LANDING GEAR - LANDING GEAR WARNING HORN REPLACEMENT

The original landing gear warning horn is no longer available. If the landing gear warning horn needs to be replaced, a new landing gear warning horn is available and will require an additional bracket for installation.

MEB-32-02  
Page 1 of 25

Figure 6. 335/340A Configuration 2 (Sheet 1)

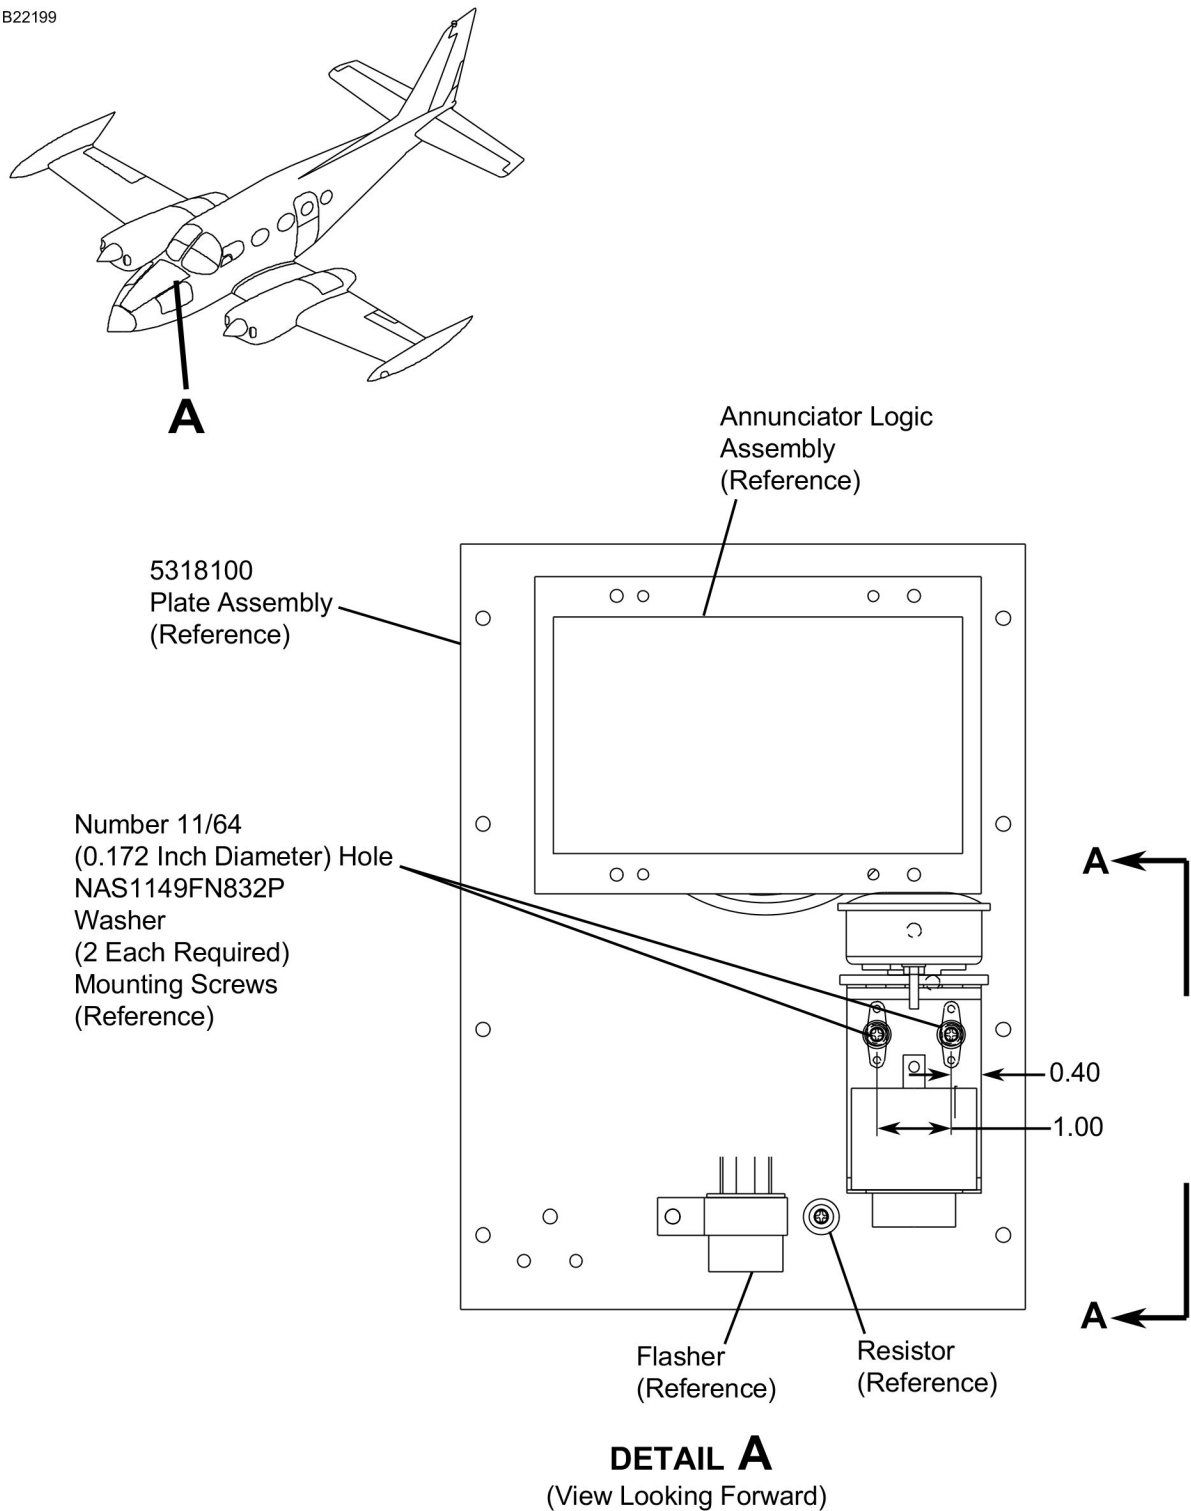
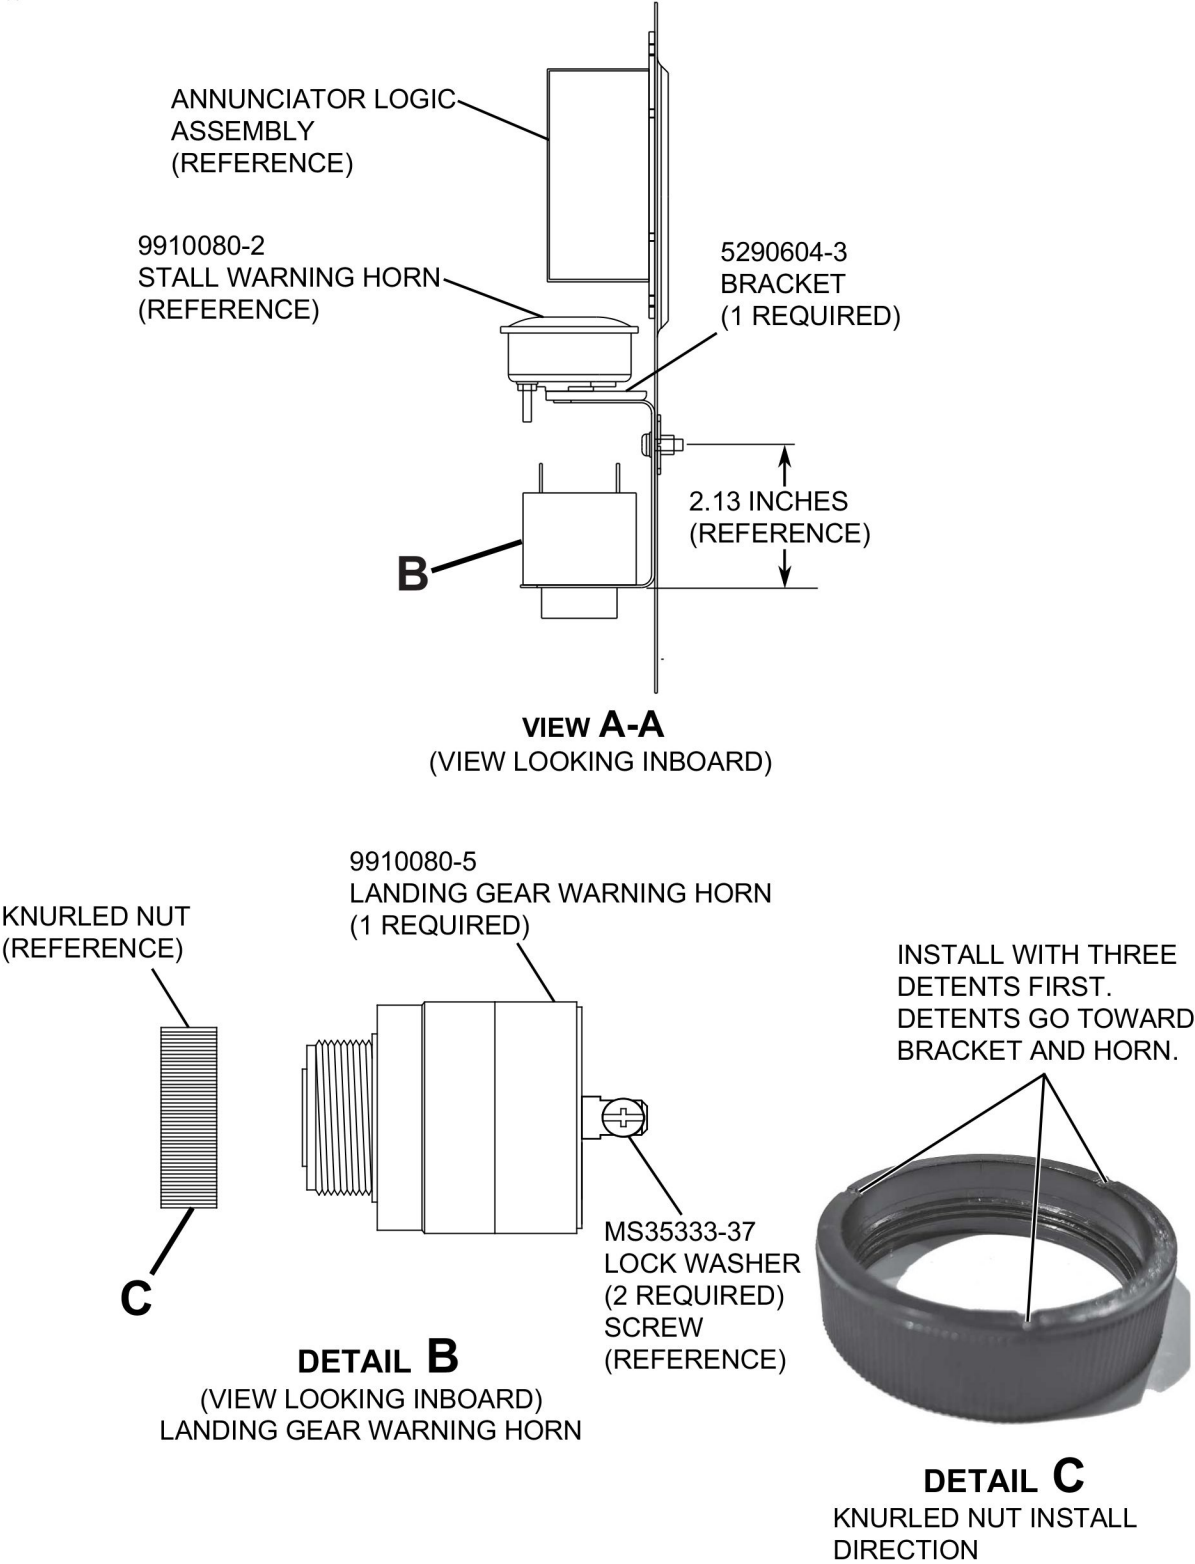
8. (For Model 340 Refer to Figure 1, Sheet 1, and for Model 335/340A Figure 2, Sheet 1.) Remove the 9910080-1 Landing Gear Warning Horn as follows:
    - A. Remove and discard the screw and lock washer from the 9910080-1 Landing Gear Warning Horn.

9. (For Model 340 Refer to Figure 5, Sheet 1 and 2, and for Model 335/340A Figure 6, Sheet 1 and 2.) Install the 9910080-5 Landing Gear Warning Horn as follows:

- (4) Go to Step 9C.
  - B. (For 335/340A airplanes.) Match drill the two Number 11/64 (0.172 inch diameter) holes of the 5318100 Plate Assembly to the 5290604-3 Bracket.

- (1) Debur the drilled holes from the 5290604-3 Bracket.
    - (2) Apply Color Chemical Film Treatment to all bare metal.
    - (3) Install the 5290604-3 Bracket with the two kept mounting screws and the two NAS1149FN832P Washers into the 5318100 Plate Assembly.

- C. Install the 9910080-5 Landing Gear Warning Horn into the 5290604-3 Bracket.
  - D. Install the knurled nut onto the 9910080-5 Landing Gear Warning Horn.

Figure 8. 335 Configuration 3 (Sheet 1)

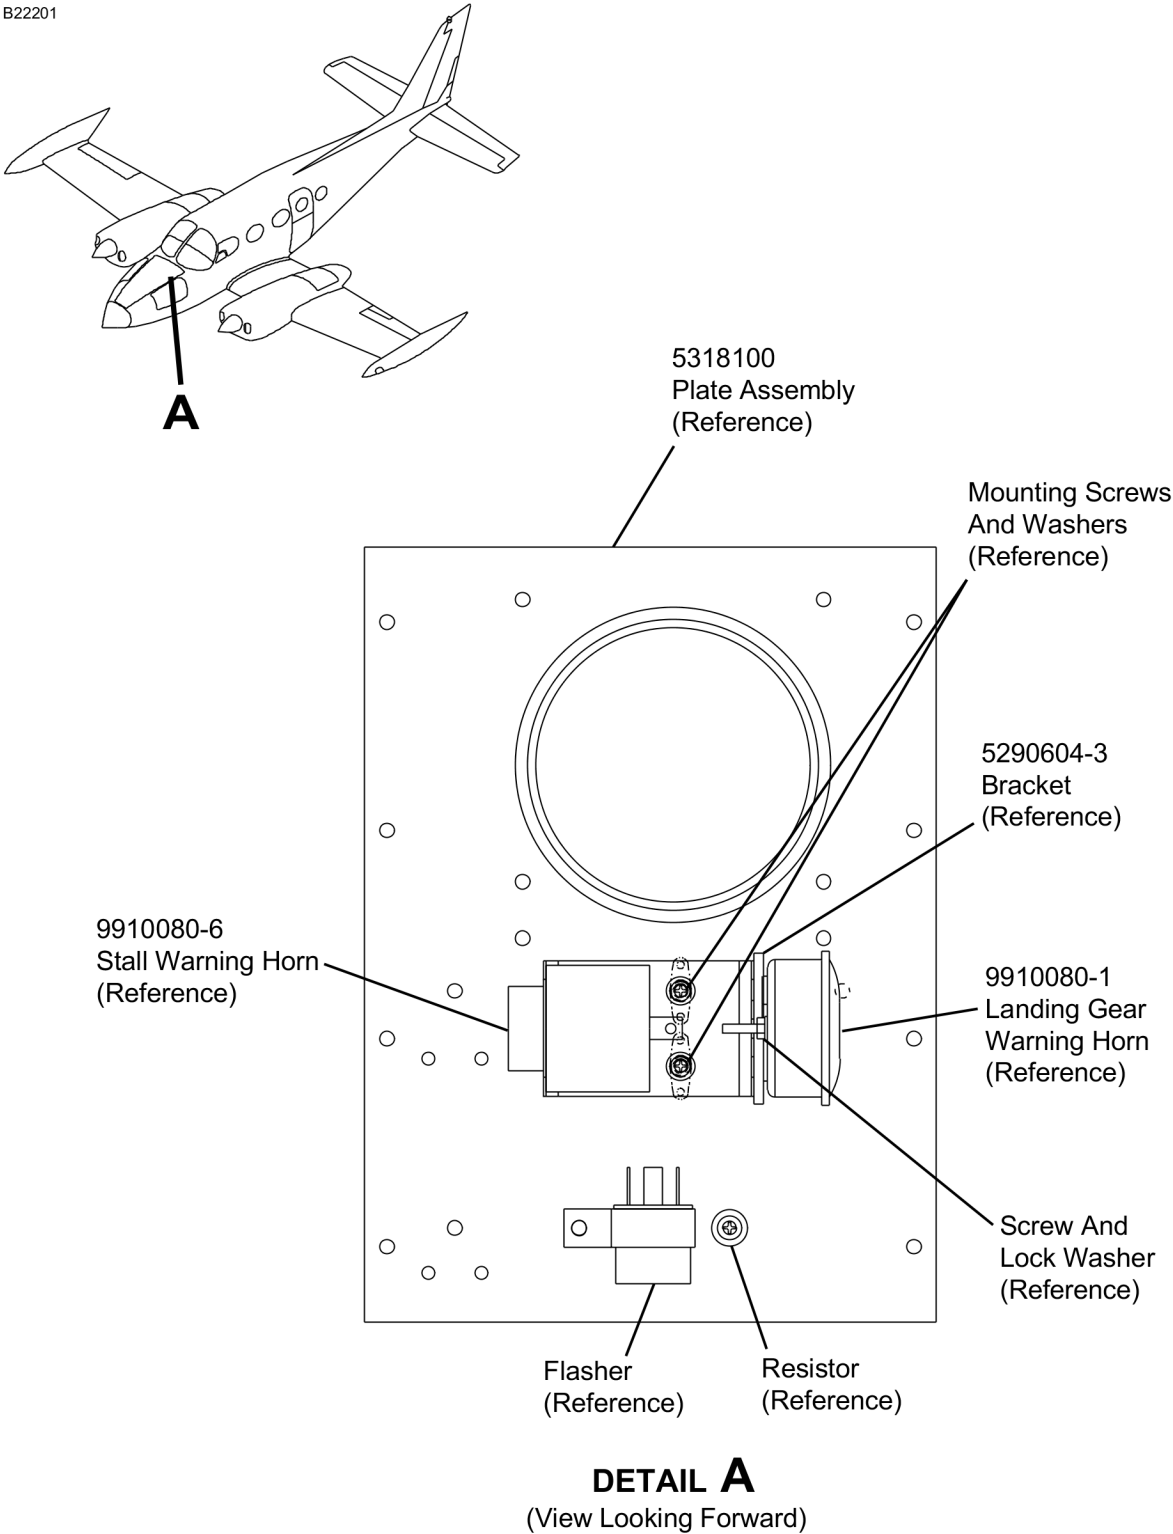
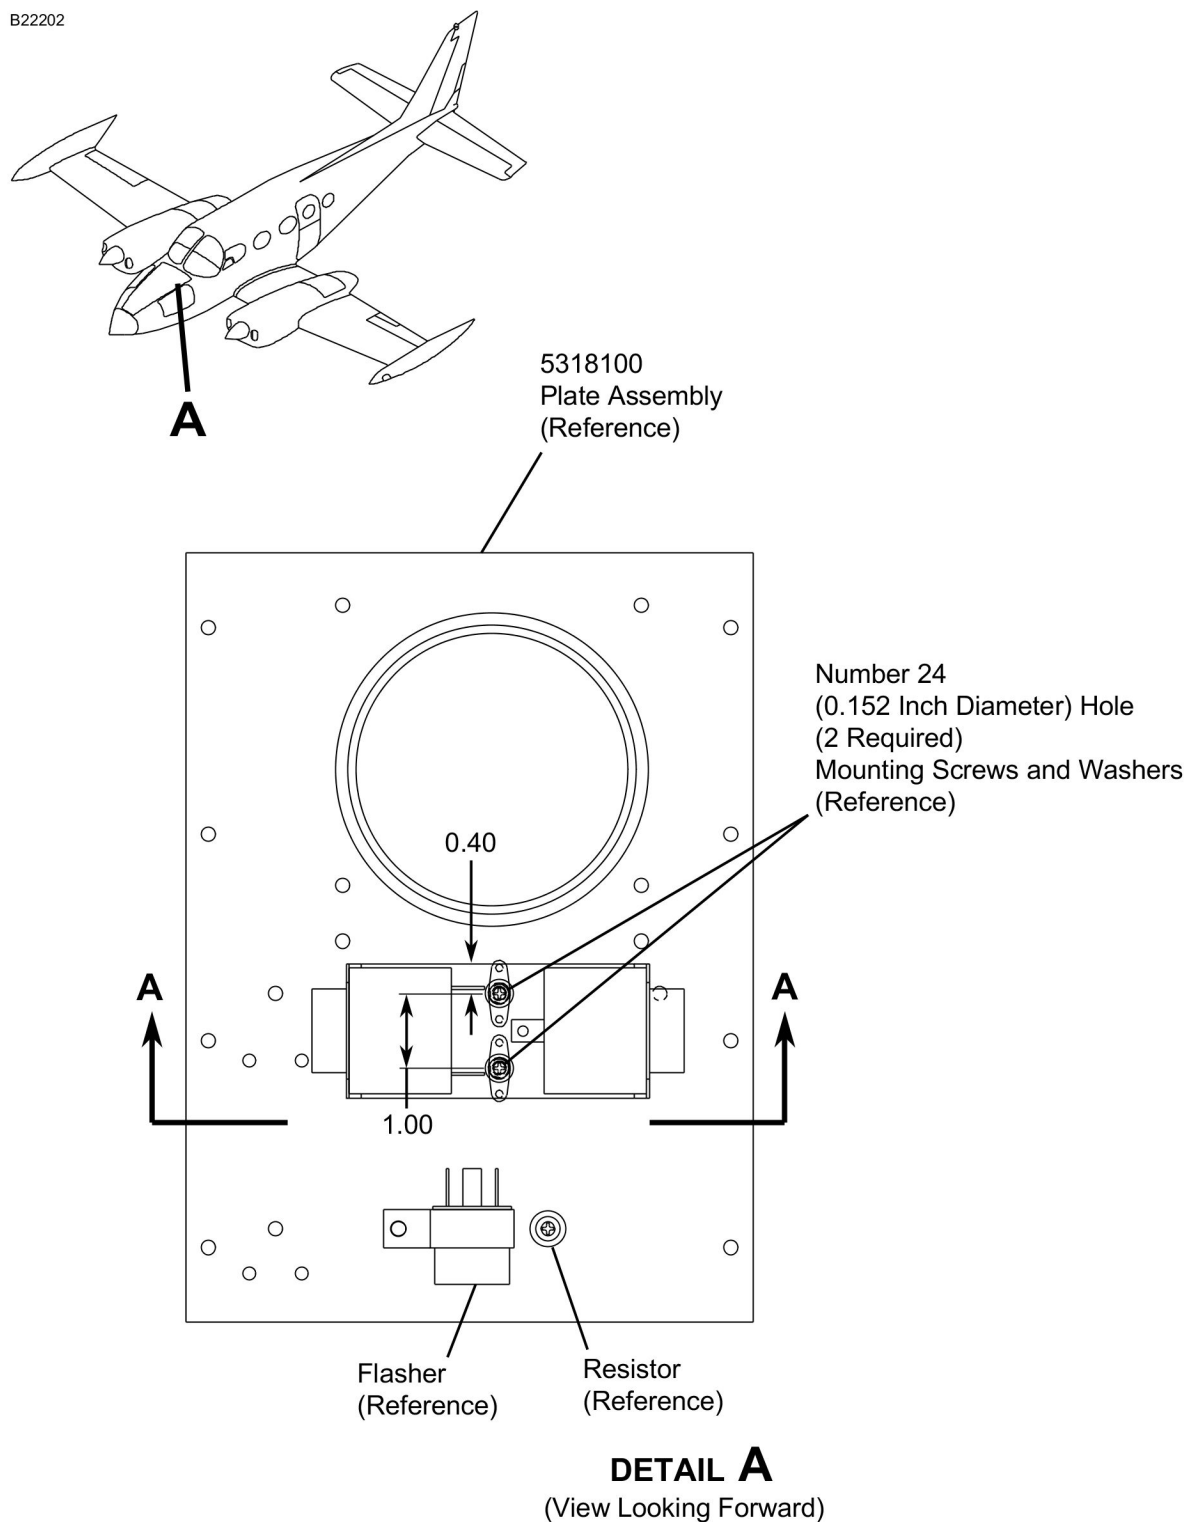
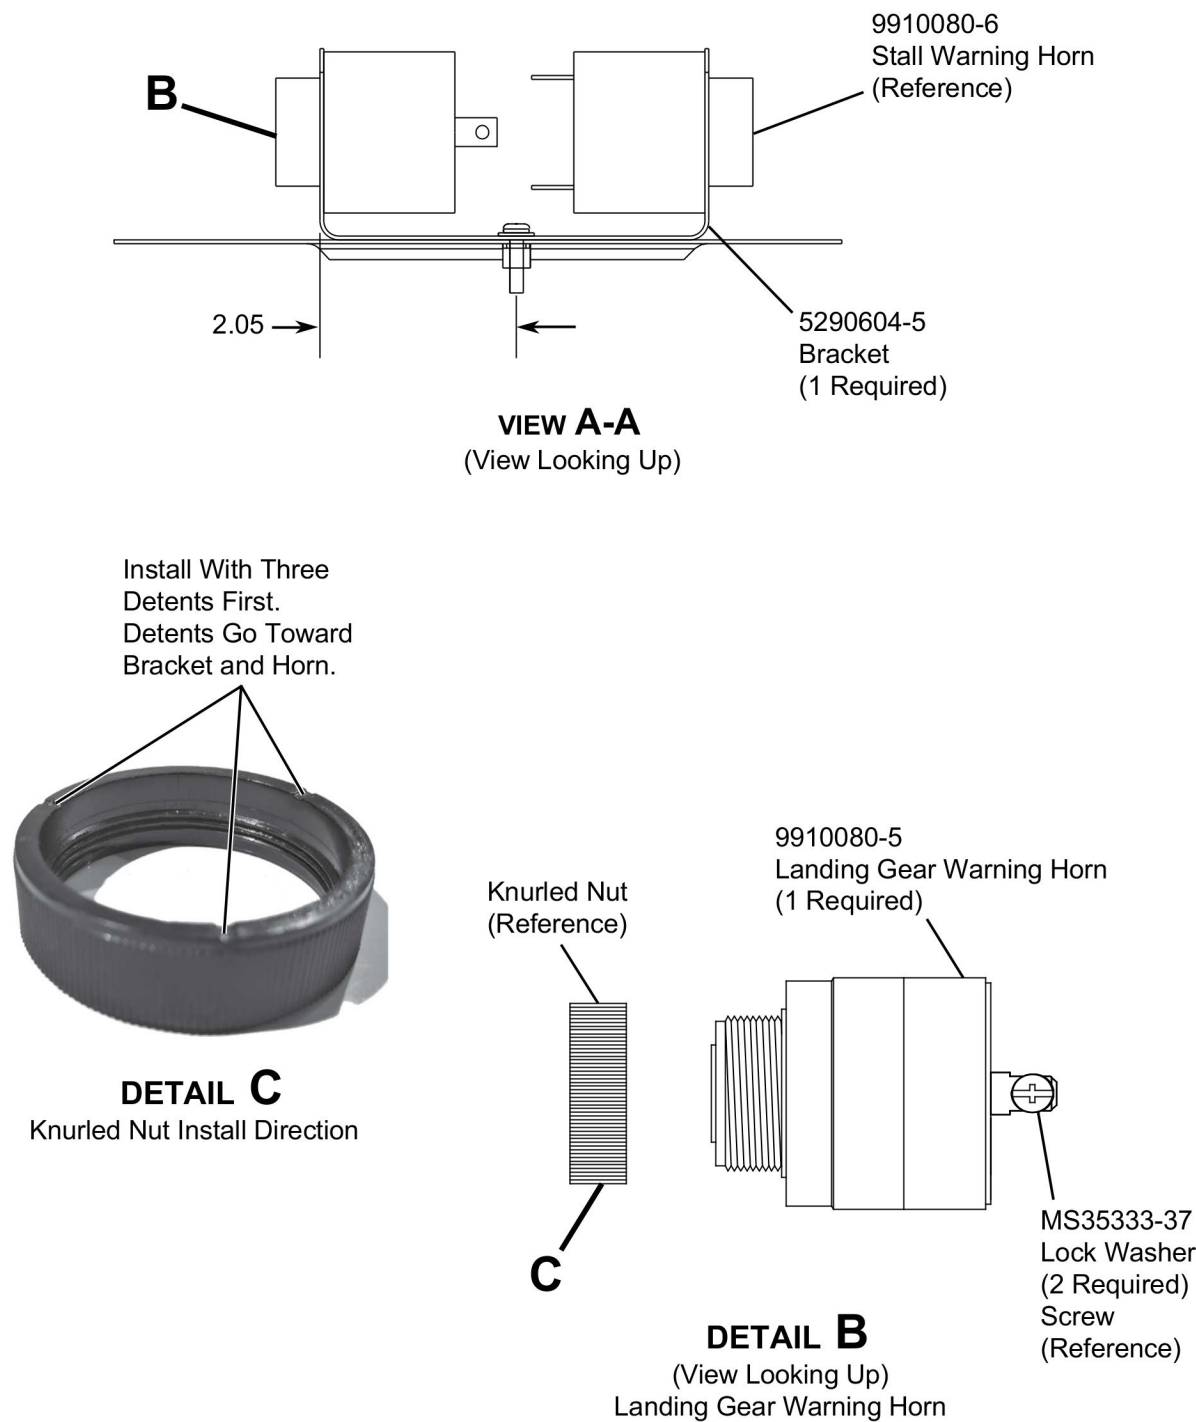
14. (For Model 340 Refer to Figure 7, Sheet 1, and for Model 335/340A Figure 9, Sheet 1.) Remove the 9910080-1 Landing Gear Warning Horn as follows:
- A. Remove and discard the washer and lock screw from the 9910080-1 Landing Gear Warning Horn.
  - B. Disconnect and label the electrical wiring from the 9910080-1 Landing Gear Warning Horn.
  - C. Discard all electrical hardware from the 9910080-1 Landing Gear Warning Horn.
  - D. Discard the 9910080-1 Landing Gear Warning Horn.
  - E. Remove and keep the 9910080-6 Stall Warning Horn.

15. (For Model 340 Refer to Figure 8, Sheet 1 and 2, and for Model 335/340A Figure 10, Sheet 1 and 2.) Install the 9910080-5 Landing Gear Warning Horn as follows:

- A. (For Model 340 airplanes.) Match drill the two Number 24 (0.152 inch diameter) holes of the 5318100 Plate Assembly to the 5290604-5 Bracket.
  - (1) Debur the drilled holes from the 5290604-5 Bracket.
  - (2) Apply Color Chemical Film Treatment to all bare metal.
  - (3) Install the 5290604-5 Bracket with the two kept mounting screws and the two kept washers into the 5318100 Plate Assembly.
  - (4) Go to Step 15C.

- C. Install the 9910080-5 Landing Gear Warning Horn into the 5290604-5 Bracket.
